BARINGER 2025 REPLAT NO. 1

**ITEM #1 - PRELIMINARY PLAT
BARINGER 2025 REPLAT NO. 1**

KPB File No.	2025-072
Plat Committee Meeting:	June 9, 2025
Applicant / Owner:	Paul Roderick of Anchor Point, Alaska
Surveyor:	Christopher Mullikin; Mullikin Surveys, LLC
General Location:	Near milepost 2 North Fork Road

STAFF REPORT

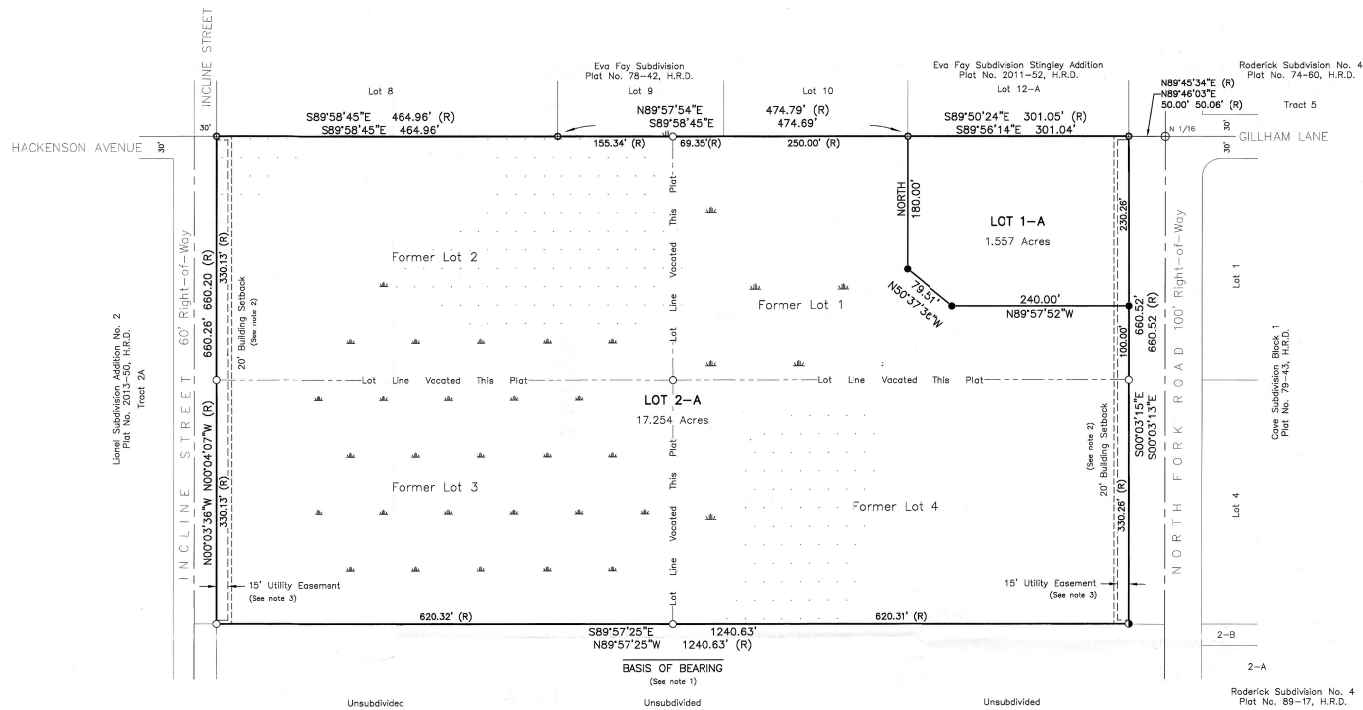
KPB Records indicate there is a 66-foot Section Line Easement within the North Fork Road right-of-way. **Staff recommends** the surveyor verify the section line easement and depict it on the plat.

A soils report will be required and an engineer will sign the final plat for proposed Lot 1-A as the new lot is less than 200,000 sq ft (67,822.92 sq ft) per KPB 20.40. **Staff recommends** the surveyor include the proper Wastewater Disposal note to the final plat with reference to proposed Lot 1-A.

A soils report will not be required for proposed Lot 2-A as the new lot is greater than 200,000 sq ft (751,584.24) per KPB 20.40.030. The correct Wastewater Disposal note has been added to the preliminary plat as plat note number 7. **Staff suggests** the surveyor include reference to proposed Lot 2-A in the note.

In the Plat Approval, change the date to June 9, 2025

- Staff suggests including the entire parent plat name for consistency: Baringer Subdivision 2025 Replat No. 1
- Include the full mailing address for Paul Roderick: PO Box 377, Homer, AK 99603
- Modify the KPB File Number to 2025-072.

- There appears to be a 66' SLE is located within North Fork Road. Please verify and depict and include a label on the plat.
- To the NE of the proposed plat: Gillham Lane should be Cave Avenue (SN Res 1996-05).
- To the NW of the proposed plat: Haakenson Avenue.
- Provide a note for North Fork Road, HM 85-35 Page 4 of 6.

- Please include the entire name for North Fork Anchor River
- There appears to be a river on the vicinity map through sections 1 and 11-12 that do not coincide with imagery. Please verify and remove if needed.
- There appears to be a river connecting to the North Fork Anchor River in section 26 that does not coincide with KPB GIS records. Please verify and remove if needed.

- Correct the utility easement line at the 5' side line to go from the 15' back to the 20' setback. Currently is shown as going from the front lot line to the 15' line.
- Add 5' utility easement at joint line of lot 1-A and 2-A
- Add 5' sideline easement where former lot lines were.

- Depict the Transmission Line as referenced in plat note number 4

- Provide an "unsubdivided" label for the parcel to the northwest
- Correct the ROW name to "Haakenson Avenue" to the northwest
- Correct the ROW name to "Cave Avenue" to the northeast
- Include "Lot" in the labels for Lot 2-A and 2-B, HM 89-17 SE

20.60.190. Certificates, statements, and signatures required. **Staff recommendation:** modify the Certificate of Ownership and Dedication to comply with KPB code.

* Include the full mailing address for Paul Roderick: PO Box 377, Homer, AK 99603
